FINAL DRAINAGE REPORT

TRAILS AT ASPEN RIDGE Filing No. 4

Engineering Development Review Team

SF-21-024

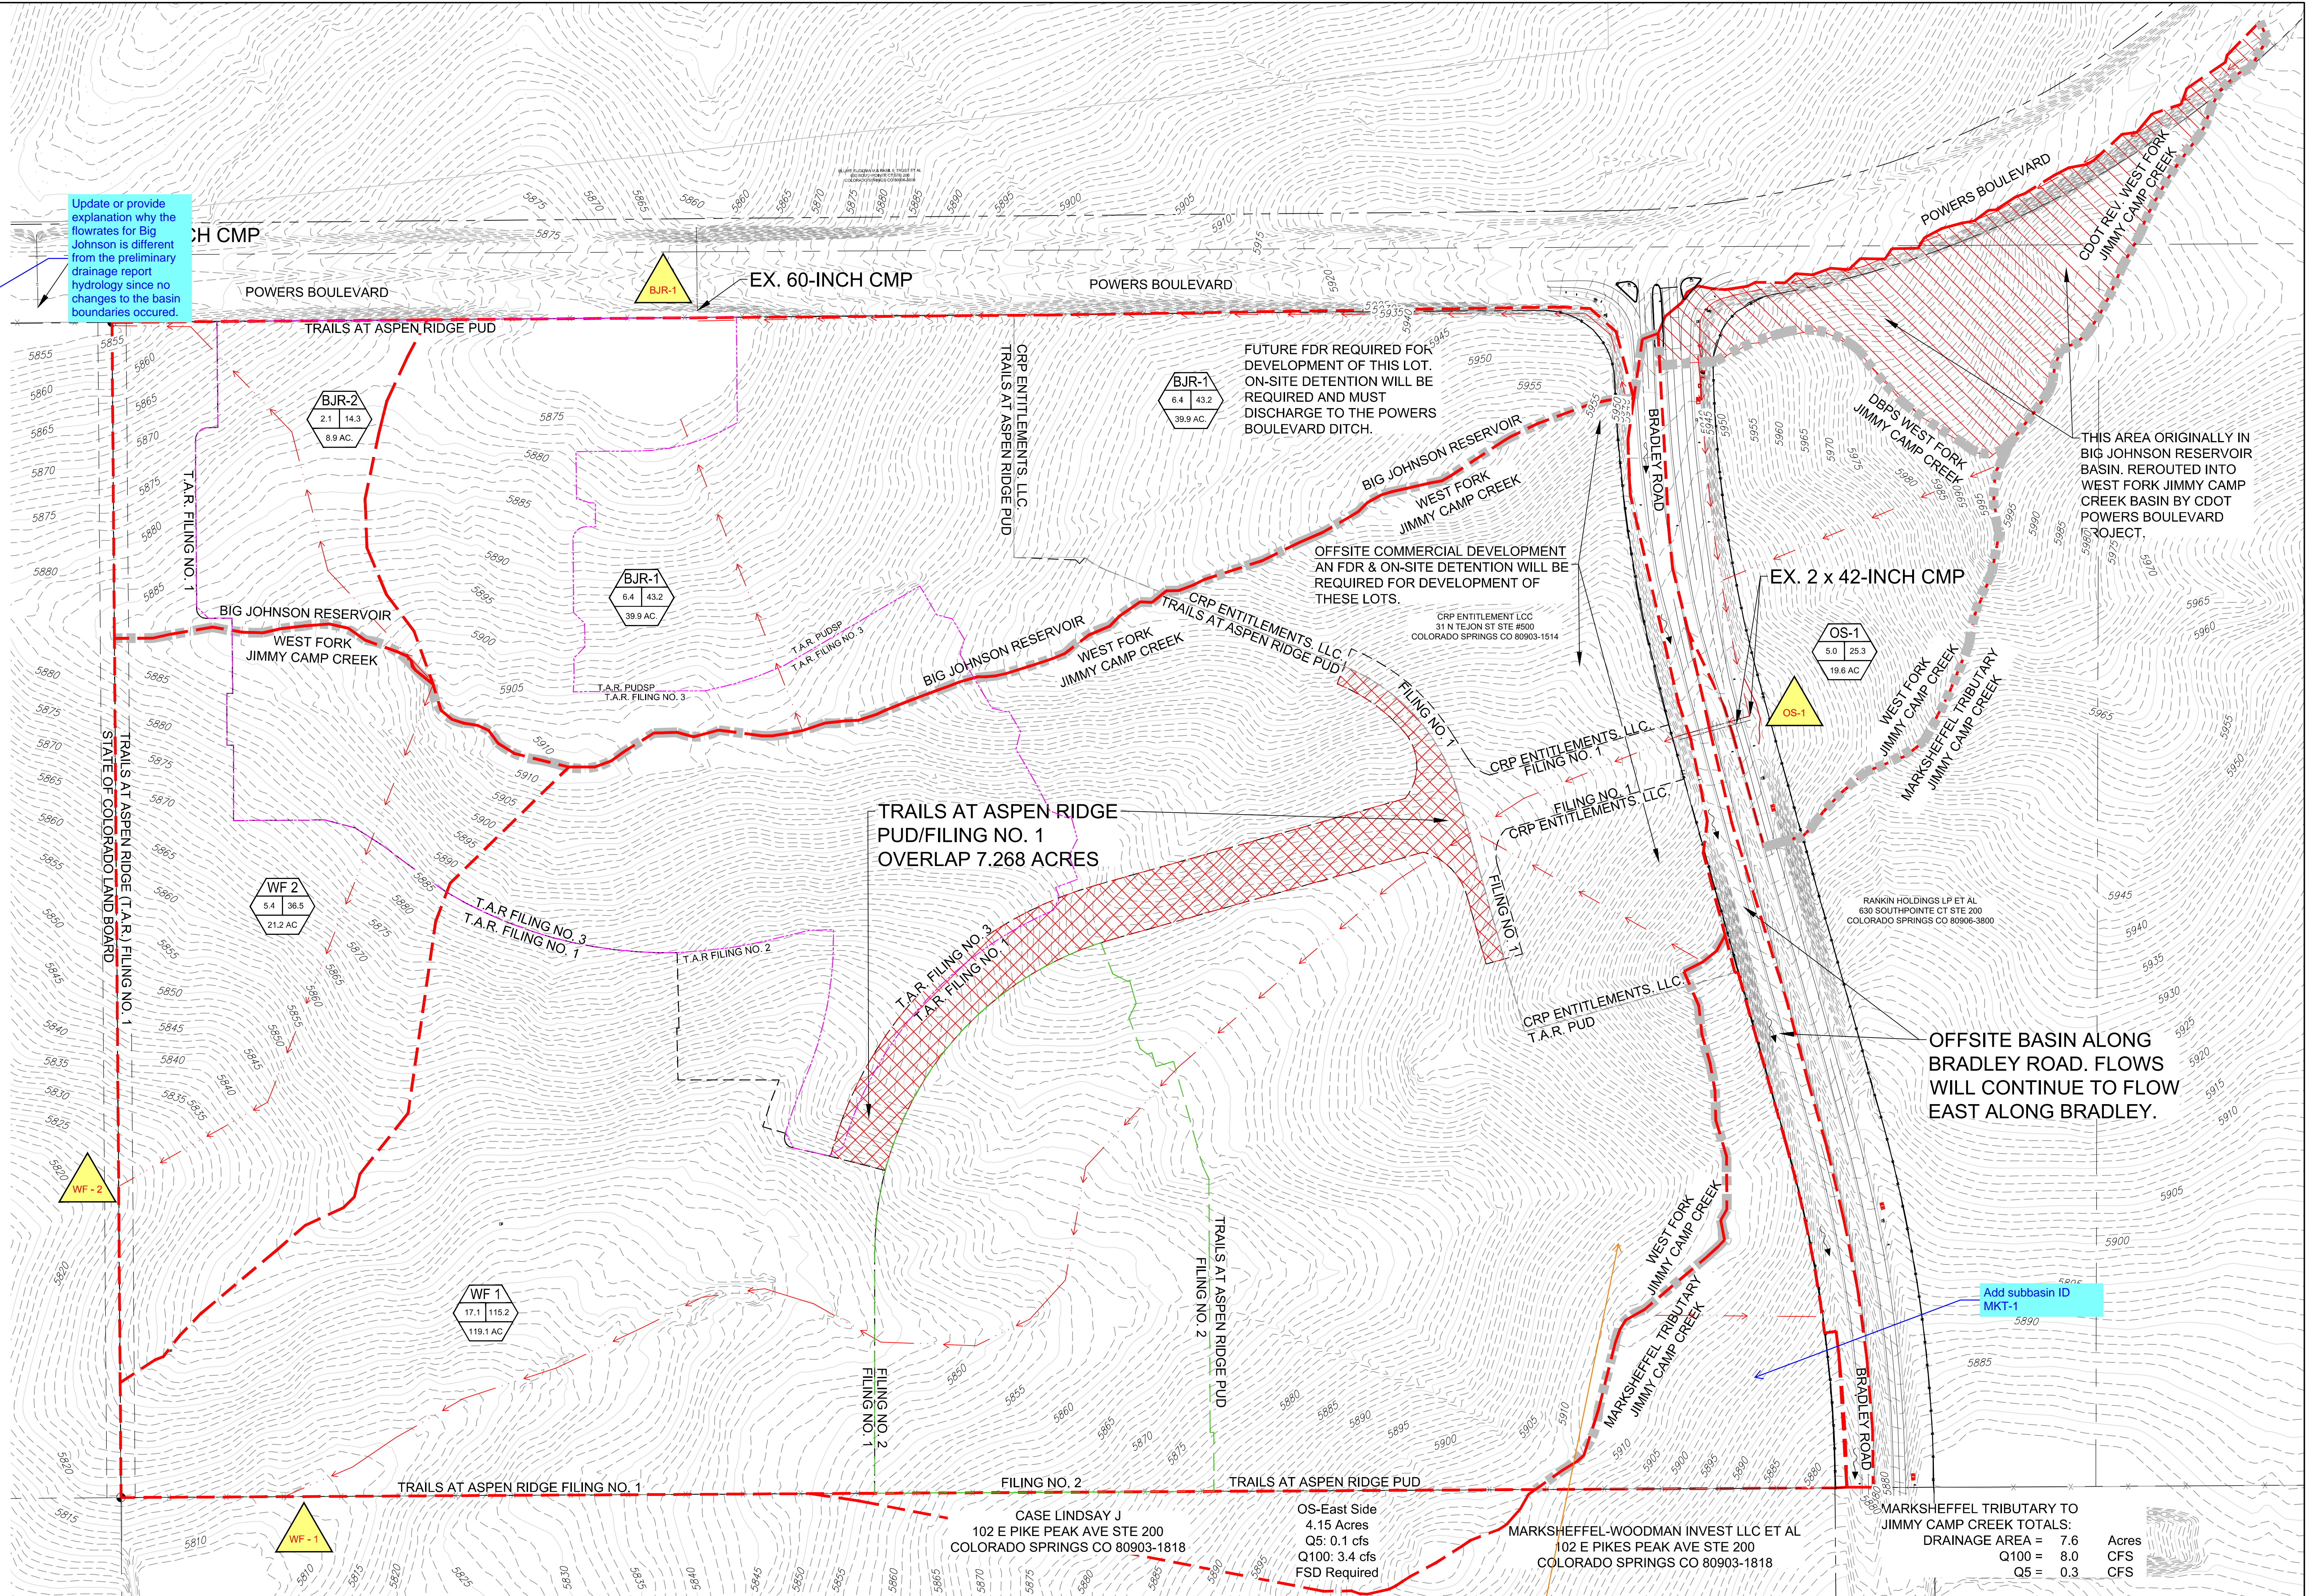
Add marksheffel tributary to Jimmy Camp Creek

Update or provide explanation why the flowrates for Big Johnson is different from the preliminary drainage report hydrology since no changes to the basin boundaries occurred.

Add subbasin ID MKT-1

Show perimeter of Filing No. 4 area.
